REMARKS

Docket No.: A0312.70388 US00
Date: May 16, 2005
x05/16/2005

In the Drawings

FIG. 7
(Prior Art)

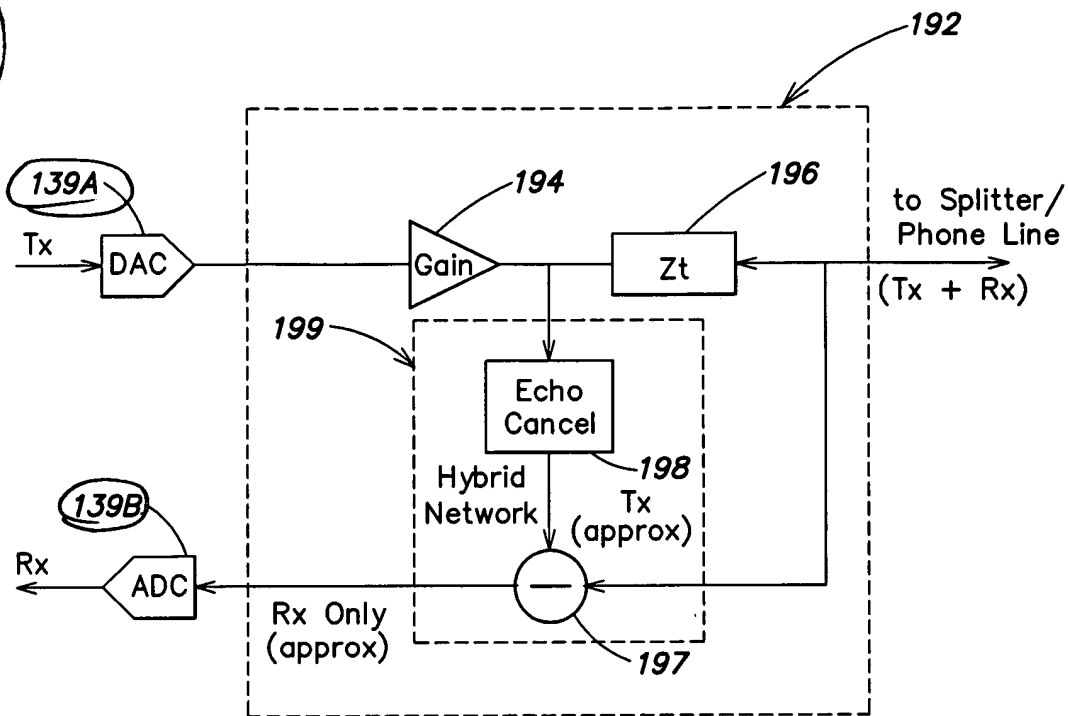
As indicated on the annotated drawing sheets, reference numbers 139A and 139B were added to Figure 7 pursuant to the specification at page 5, line 12. On Figures 15a and 15b, the numbering of curves 440 and 442 was changed to 441 and 443 to avoid double use of those reference numbers (see Fig. 14 b). In Fig. 20A, reference numbers 742, 744 and 746 were changed, respectively, to 743, 745 and 747 to avoid duplicate use of those reference numbers for different components (see elsewhere on the same Fig.). On Fig. 25, reference number 946 was changed to 814b, pursuant to the specification on page 37, line 8. On Fig. 30, the reference numeral for capacitor 1010 was changed to 1011, as the node next to it was also numbered 1010.
